Appendix I – Road Safety Audit Designer’s Responses

Adastral Park, Ipswich : Traffic Signals Access off the A12 Dual Carriageway

Technical Note : Designer's Response to Road Safety Audits at Stage 1

14th June 2017

Appendix B: Updated Design Drawing

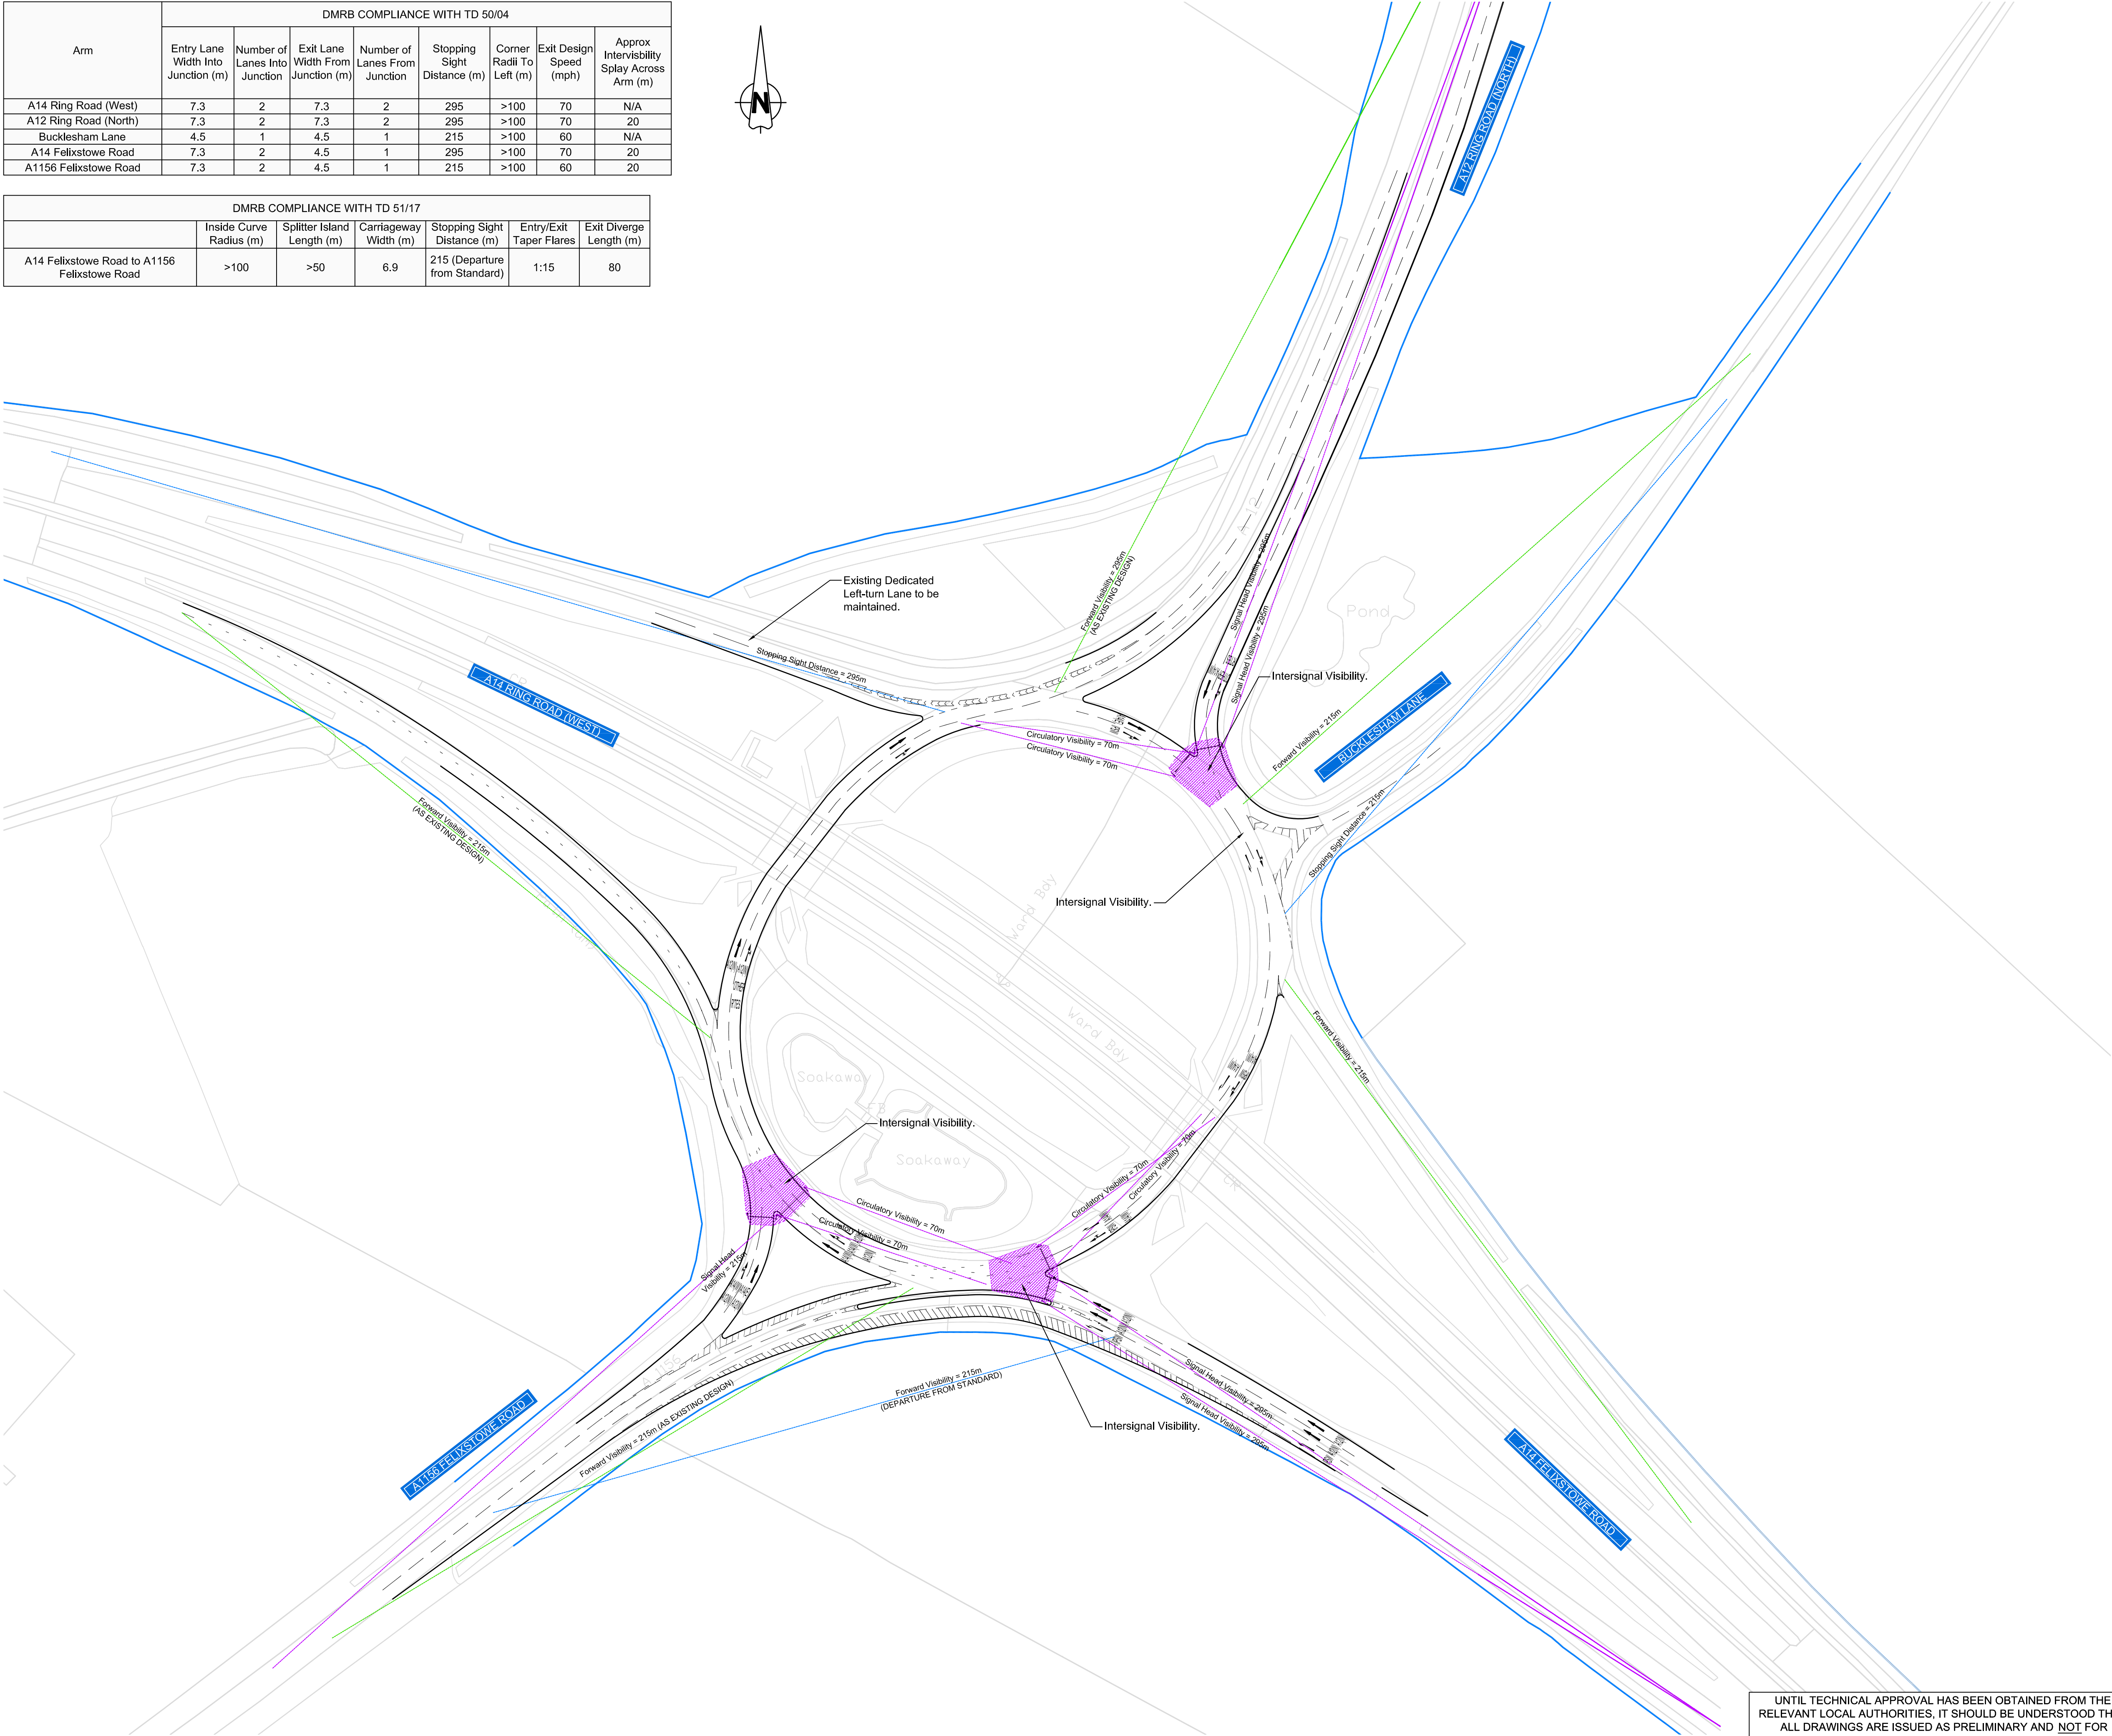
Recommendation: Provide a signal layout which ensures that drivers in the offside lane will have a view of at least one signal head at the requisite distance. One solution would be the provision of a mast arm.

Summary: Risk of sideswipes and shunts (and non-compliance with stopline). The circulatory carriageway is reduced down to one lane on approach to the signals with the A12 entry. The hatching appears to create a pinch point for the two exit lanes to the A12 Ring Road which could lead to sideswipes. It also reduces stacking capacity at the signals which could result in queuing back into the offside exit lane, which if not anticipated could result in high speed shunts. (The layout also appears to show the stopline not extending from kerb to kerb, which means vehicles can legally cross the hatching against a red light).

Recommendation: Provide two lanes on this approach, removing the hatching.

BCL Response: *High-mast traffic signals have now been provided on the A14 Westbound Off-slip approach as advised.*

BCL Response: *In TD 51/17 for the design of Segregated Left turn Lanes and Subsidiary Deflection Islands at Roundabouts, hatching is advised to be on the nearside of the curve in Paragraph 2.5.10. In addition, placing the hatching on the off-side would reduce forward visibility for vehicles travelling along this lane outside of the hatched area. Reflective features will be discussed at detailed design stage.*

BCL Response: *This has now been amended to reflect this observation.*
